**RE: Burger King – 5508 4<sup>th</sup> Street NW**  
**Grading and Drainage Plan**  
**Stamp Date: 11/09/17**  
**Hydrology File: F14D055**

Re: Burger King on 4<sup>th</sup> Street NW Drainage and Grading Plan (F14D055)

**RE: Burger King – 5508 4<sup>th</sup> Street NW**  
**Grading and Drainage Plan**  
**Stamp Date: 10/30/17**  
**Hydrology File: F14D055**

11-09-17 Richard Dourte P.E. #10854	Title BURGER KING 4TH ST. AND MONTANO RD 5508 4th Street NW	DRAWN BY DATE OCT. 2017
	GRADING AND DRAINAGE PLAN	
	RHD Engineering, LLC 4305 Purple Sage Ave. NW ALBUQUERQUE, NM 87120 (505) 288-1621	SHEET # 1 of 2 JOB #

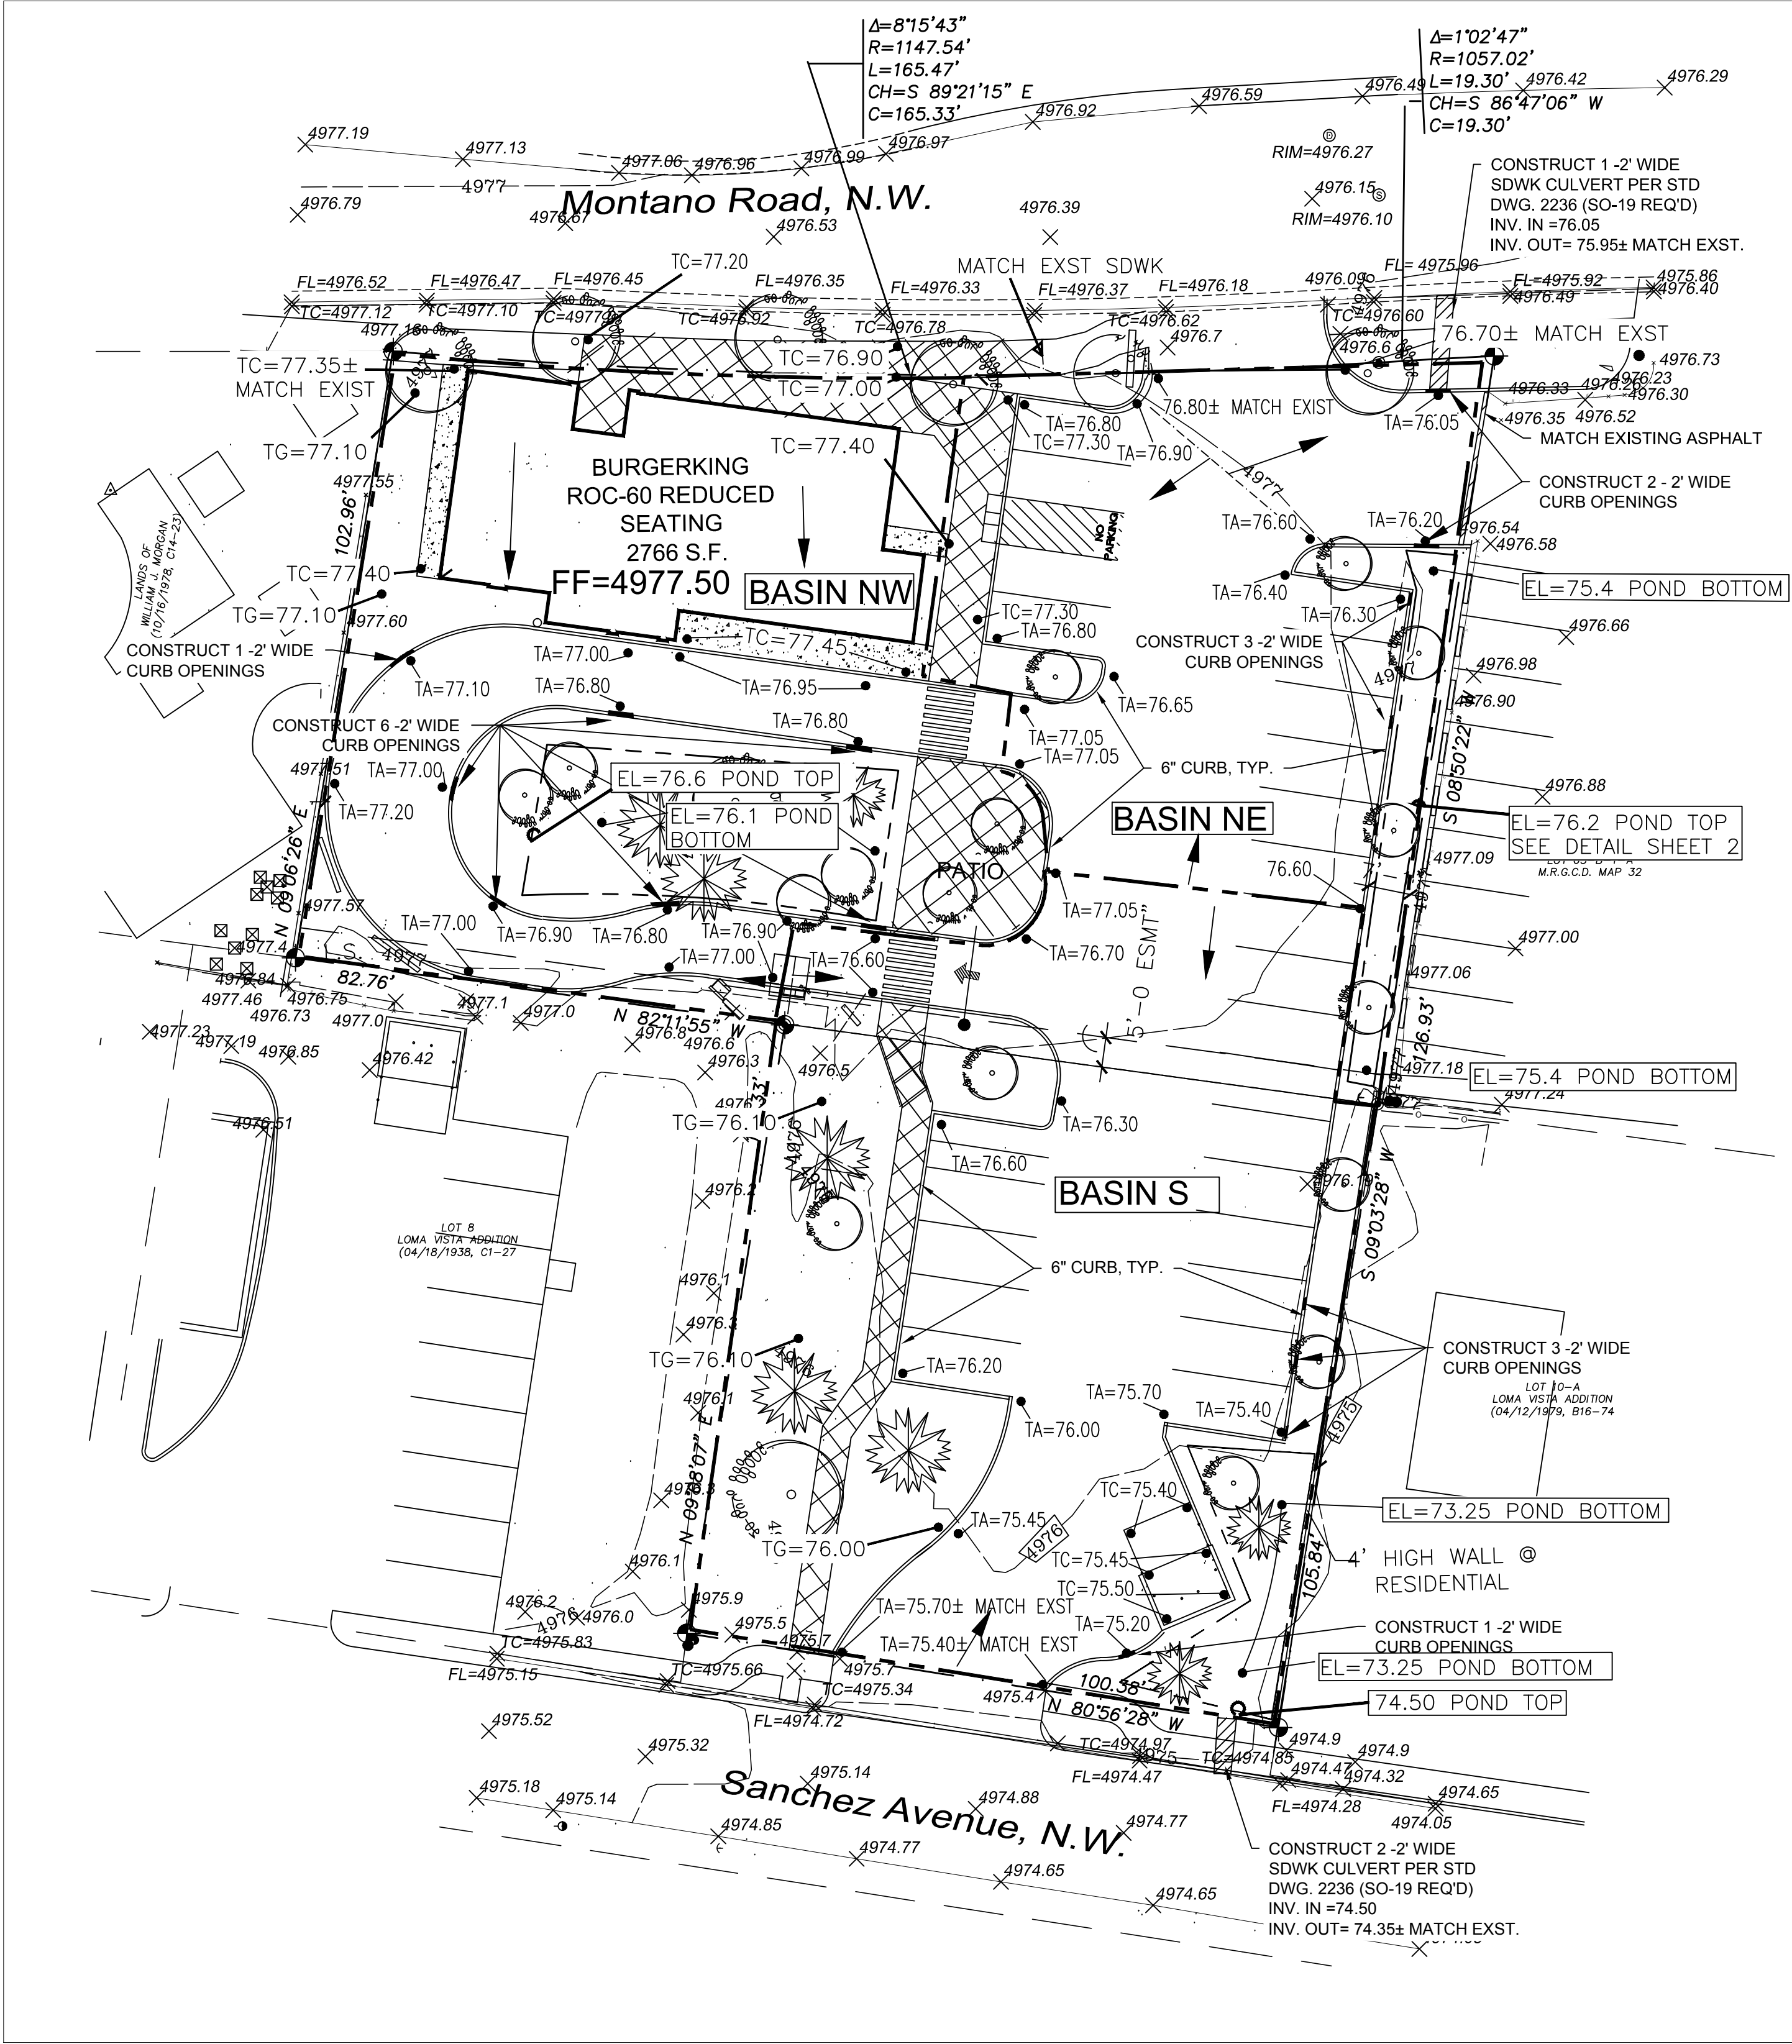
1. Please darken the property line or make the proposed basin boundary go around the property line. It is hard to tell what is within the site.

2. Please provide the weir calculations for the curb cuts and sidewalk culverts.

3. The sidewalk culverts will need a SO-19 Permit. Please mark the DTIS in your re-submittal and add the standard SO-19 notes (See below).

1. The property lines have been darkened and the basin boundaries have been modified to provide better clarity with respect to drainage basins.
2. Weir calculations have been included on the drainage plan, since the flow to the southern sidewalk culvert was at capacity another sidewalk culvert was added. This is shown on the drainage plan.
3. The sidewalk culverts will require an SO-19 permit so the notes that you requested were added to the drainage plan. The call outs for the sidewalk culverts also include a note to this effect. The DTIS form will specify the need for the SO-19.

$Q = CLH^{3/2}$   
 $C = 3.2$   
 $L = 2.0'$   
 $H = 0.5'$   
 $Q = 3.2(2.0)((0.5)^{1.5}) = 2.3CFS$  PER SIDEWALK CULVERT

BASIN NW (35%) AND BASIN S (44%) FOR A TOTAL OF 79% DRAIN TO THE SOUTH. THE ENTIRE SITE GENERATES 3.0CFS, THUS .79(3.0CFS)=2.4CFS DRAINS TO THE SOUTH. 2 SIDEWALK CULVERTS ARE NEEDED.

BASIN NE (21%) DRAINS TO THE NORTH. THE ENTIRE SITE GENERATES 3.0CFS, THUS .21(3.0)=0.63CFS DRAINS TO THE SOUTH. 1 SIDEWALK CULVERT IS NEEDED.
